Agenda for **57th PCC meeting**

EASTERN REGIONAL POWER COMMITTEE

AGENDA FOR 56TH PROTECTION SUB-COMMITTEE MEETING TO BE HELD AT ERPC, KOLKATA ON 25.07.2017 (TUESDAY) AT 11:00 HOURS

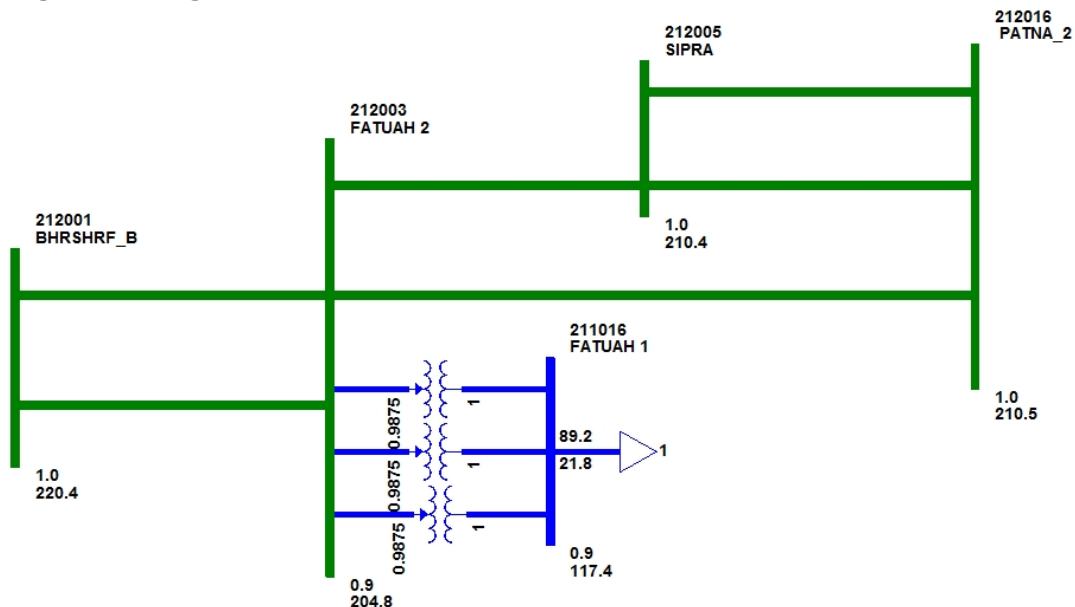
- At 20:27:12.340 hrs and 20:27:13.280 hrs R-N fault has been observed in PMU data.
- In first case, fault clearing time is less than 100 ms
- In second case fault clearing time is 200 ms approx.

BSPTCL, JUSNL and Powergrid may explain the following:

- Reason for tripping of both circuit of 220 kV Ranchi – Hatia D/C for fault in Circuit I may be explained.
- Reason for tripping of 220 kV TVNL – Biharshariff S/C from TVNL end in Z-II may be explained
- Status of 220 kV Sipara – Fatuah S/C prior to the incident may be explained.
- In PMU data, two voltage dip in Y phase have been observed. Reason may be explained

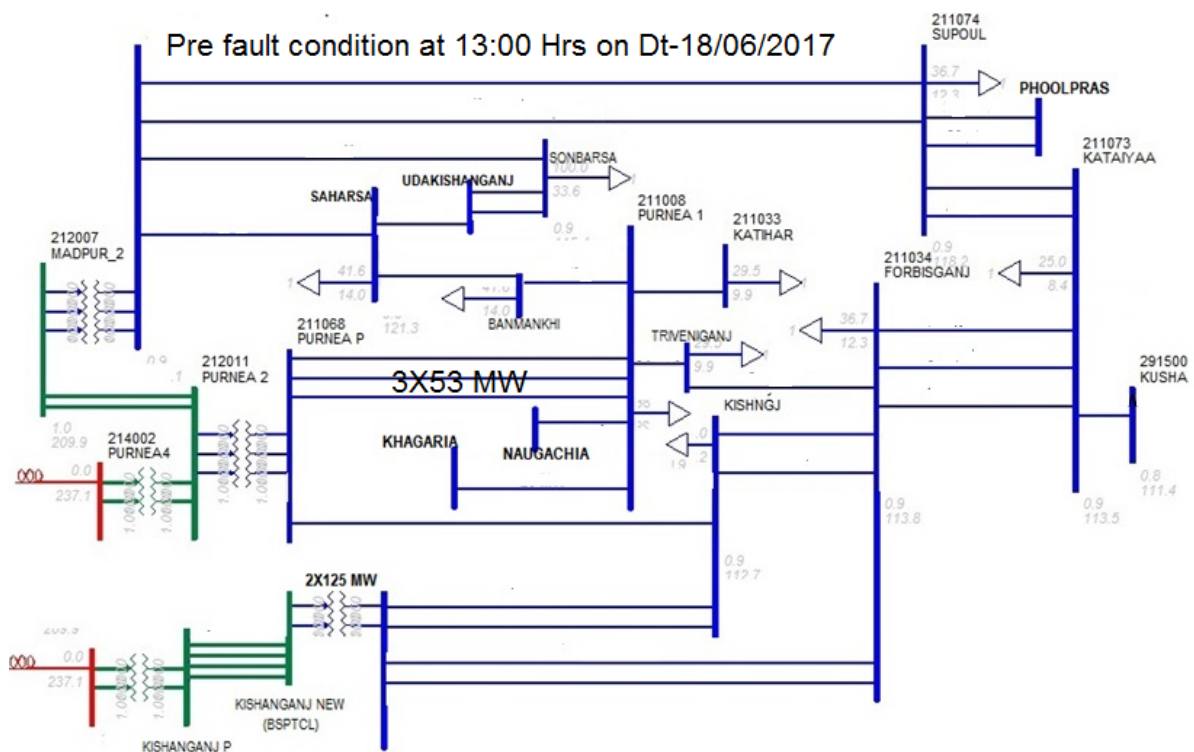
- Fault clearing time 1200 ms (Y-N fault) and 500 ms (B-N fault)

BSPTCL and Powergrid may explain the following:

- Location of fault
- Reason for tripping of 220 kV Biharshariff - Fatuah - I & II

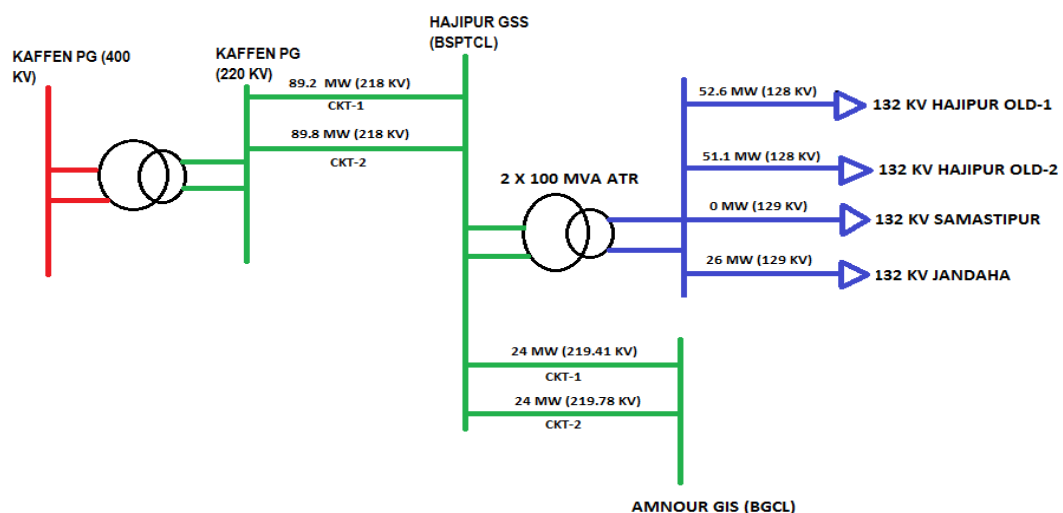
- Fault clearance time is 840 ms

BSPTCL may explain the following:

- Reason for delayed fault clearing from 132kV/33kV Transformers

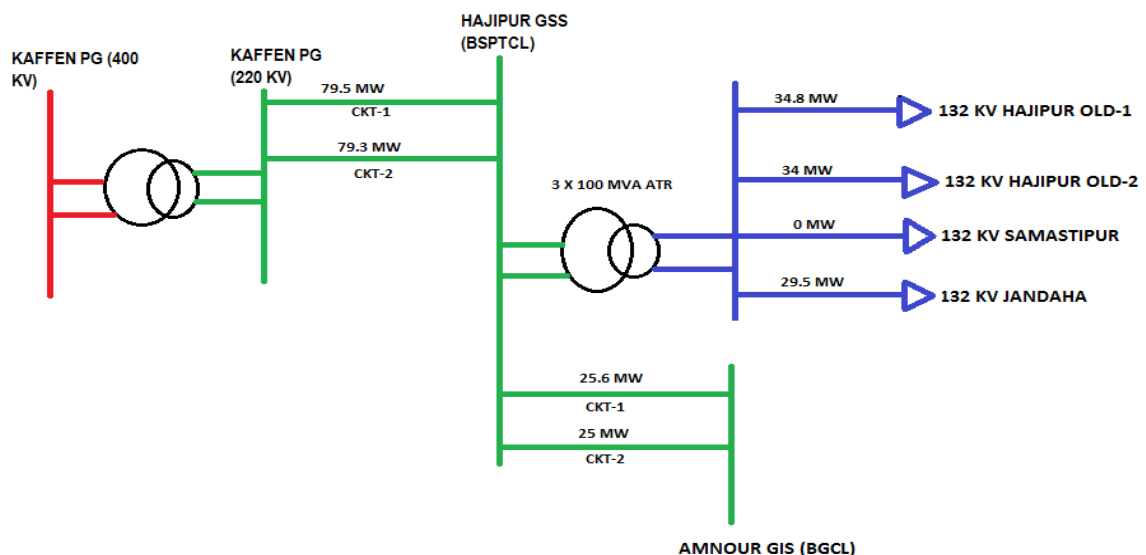
- Fault clearance time is less than 100 ms

Powergrid and BSPTCL may explain the following:

- Amnour end tripping details of 220 KV Hajipur-Amnour Ckt-1
- Reason for tripping of 220 KV Muzaffarpur-Hazipur-D/C line from Muzaffarpur end on zone 2 as the fault was already cleared within 100 ms (as per PMU data). Powergrid may share the zone 2 time setting at Muzaffarpur end.

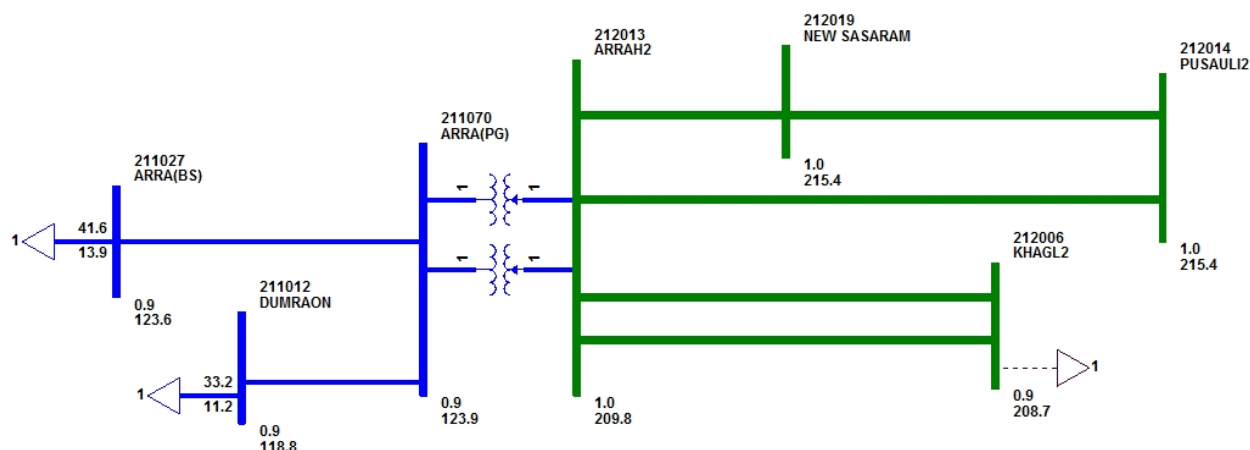
- Fault clearance time is 600 ms

BSPTCL may explain the following:

- Prefault conditions
- Tripping details at Begusarai end
